STANDARD DEPARTURE CHART - INSTRUMENT

RJNH / HAMAMATSU

INSTRUMENT APPROACH CHART

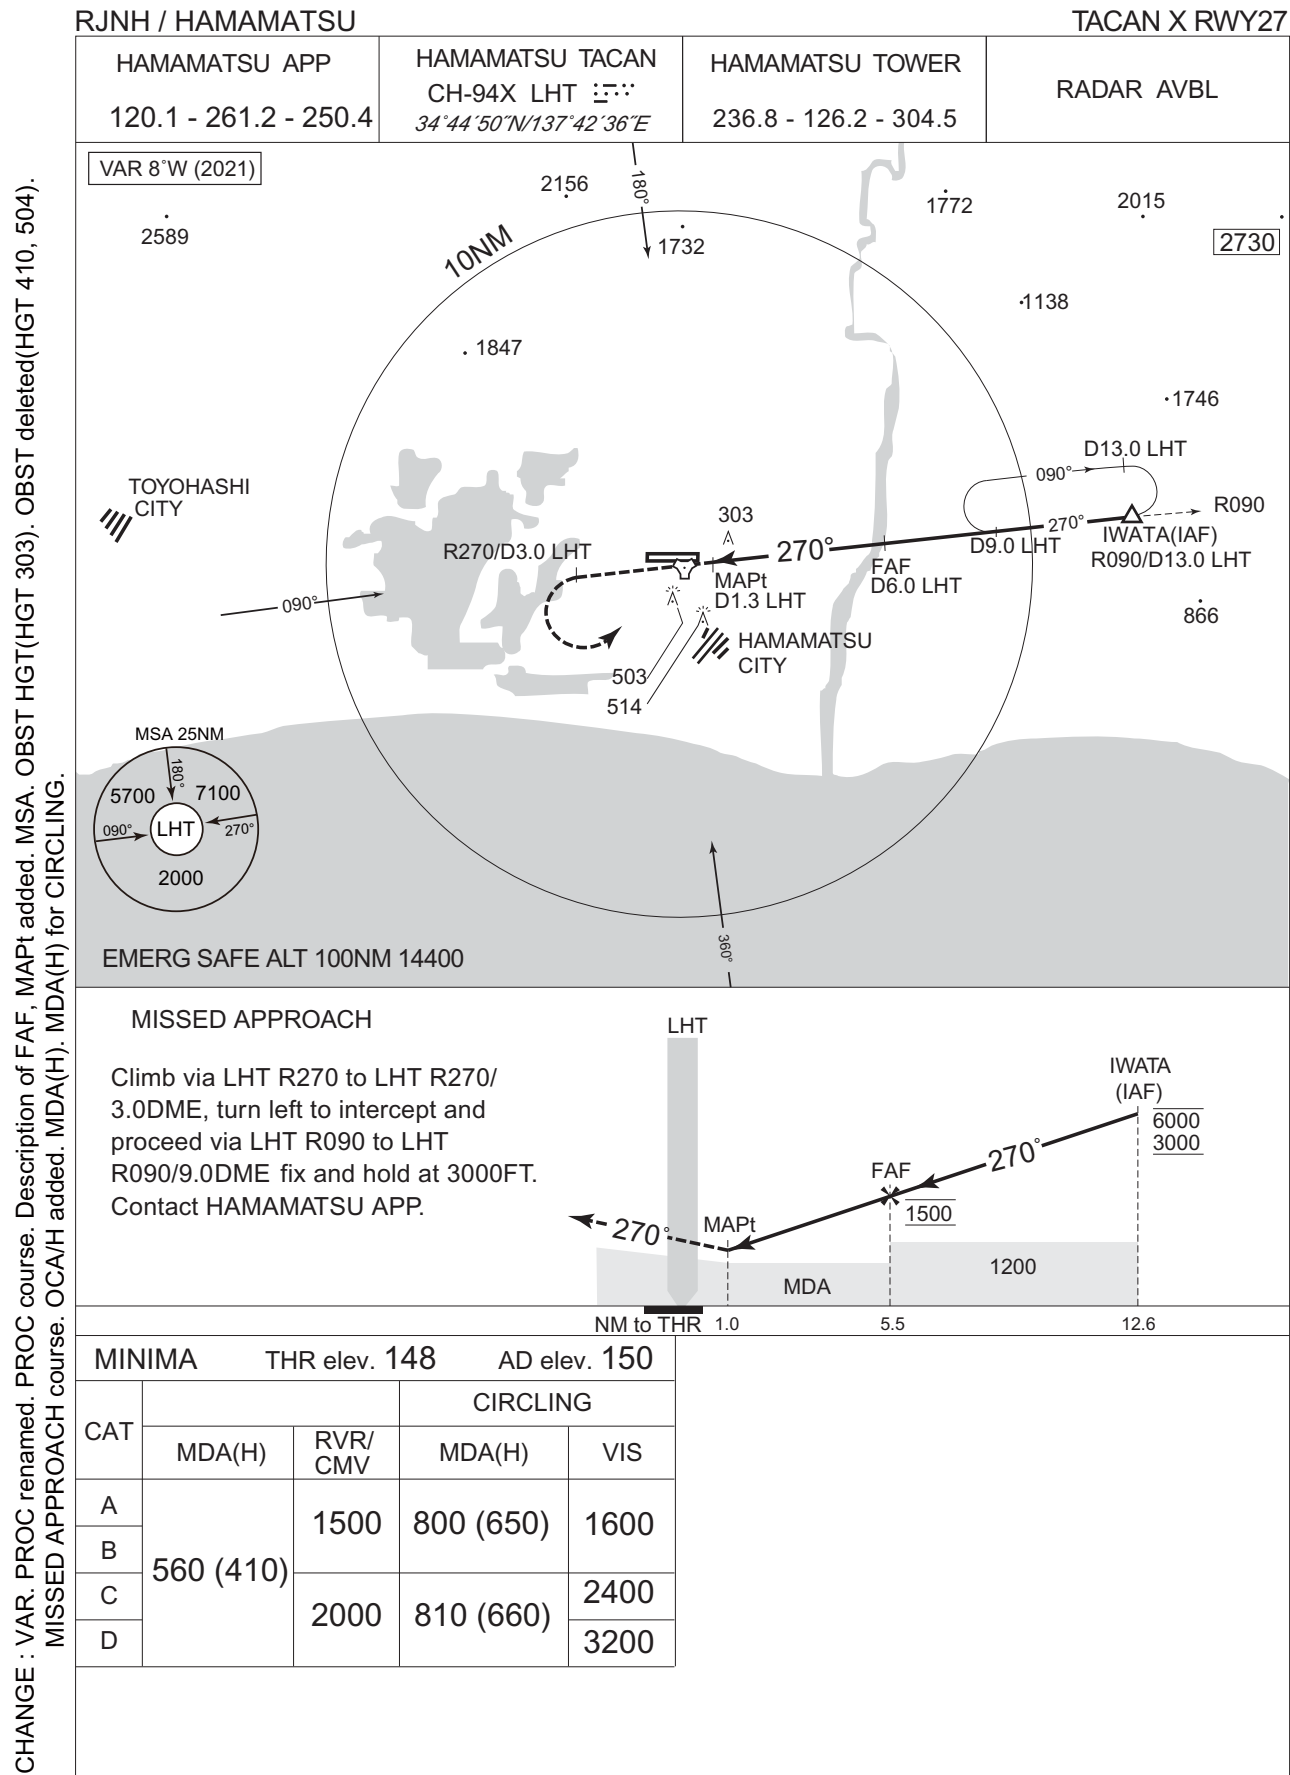
CHANGE : VAR. PROC renamed. PROC course. Description of FAF, MAPt added. MSA. OBST HGT(HGT 303). OBST deleted(HGT 410, 504). MISSED APPROACH course. OCA/H added. MDA(H). MDA(H) for CIRCLING.
